**SOUTH DAKOTA
WATER PERMIT NO. 1686-1**

PES Review

Water Permit Application No. 1686-1
Bob Samuelson

REPORT ON
WATER PERMIT APPLICATION NO. 1686-1
Bob Samuelson
June 11, 1999

~~SKETCH PLAN OF DAM AND RESERVOIR AREA~~

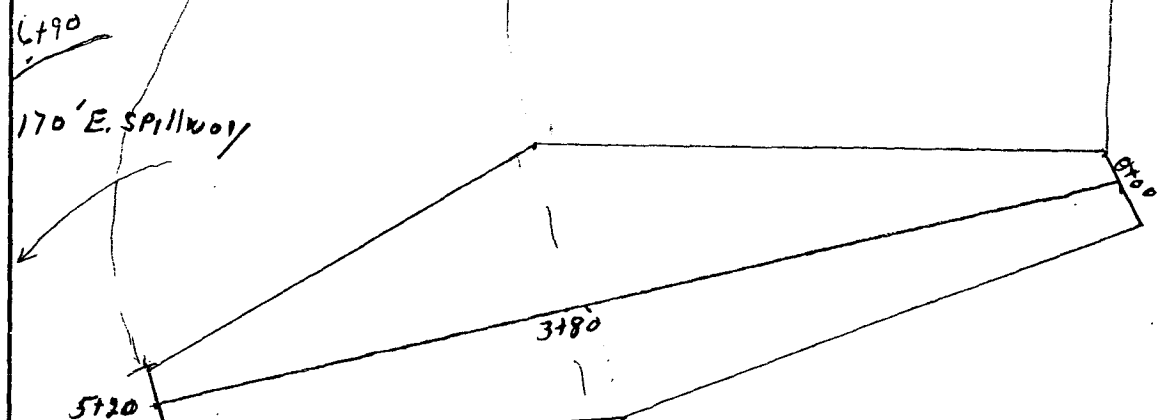
1. Topo Map - OK
2. Dam Axis Profile - OK
3. Dam Max X-Sec - OK
4. Area Capacity - OK
5. Outlet Details - N/A - OK
6. Spillway Rating - OK
7. Spillway Details - OK
8. Specs - Std. NRCS - OK
9. EPP - N/A Cat. 3 - OK
